18C Operator Interface Equipment Characterization

The information in this appendix of the reference ABWR DCD, including all subsections and figures, is incorporated by reference with the following departures and a supplement.

Figure 18C-8 Overall Configuration of Operator Interface System

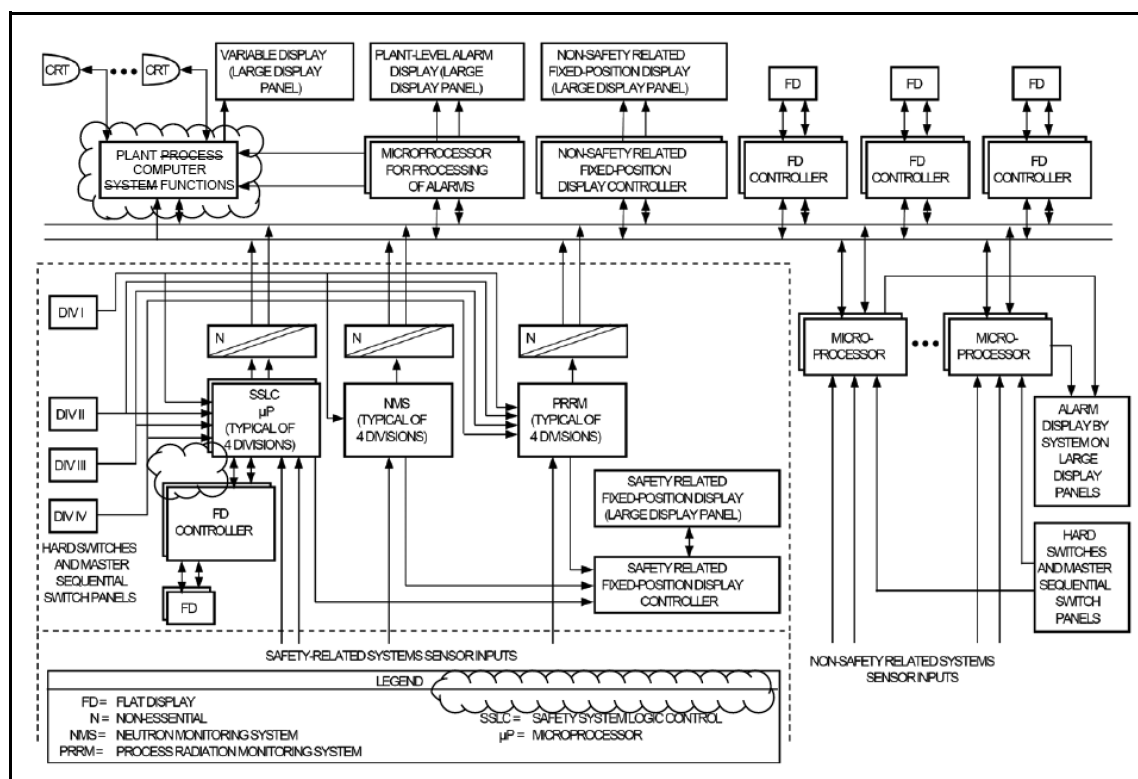
STD DEP T1 3.4-1 (Figure 18C-8)

A characterization of the plant instrumentation and control systems architecture which supports the control room operator interface is illustrated in Figure 18C-8. As shown in Figure 18C-8, display and control capability for both safety-related and non-safety-related systems are driven by microprocessors which are independent of the redundant plant process computer functions. This assures the ability to safely shut down the plant in the unlikely event of computer failure. In the case of the safety-related systems, the microprocessors are divisionally dedicated and are each electrically isolated from the rest of the system.

The instrumentation and control systems architecture is not identical to the conceptual design described in Appendix 18C. The changes in the next paragraph reflect the architecture and configuration.

~~The plant wide, fiber optic Essential Multiplexing System (EMUX) provides the communications network for the system. This multiplexing system is actually a series of data acquisition and control networks, separate networks being provided for safety related and non safety related plant systems.~~ The data communication function includes both safety-related and non-safety-related communication performed by separate networks as described in Section 7.9S.
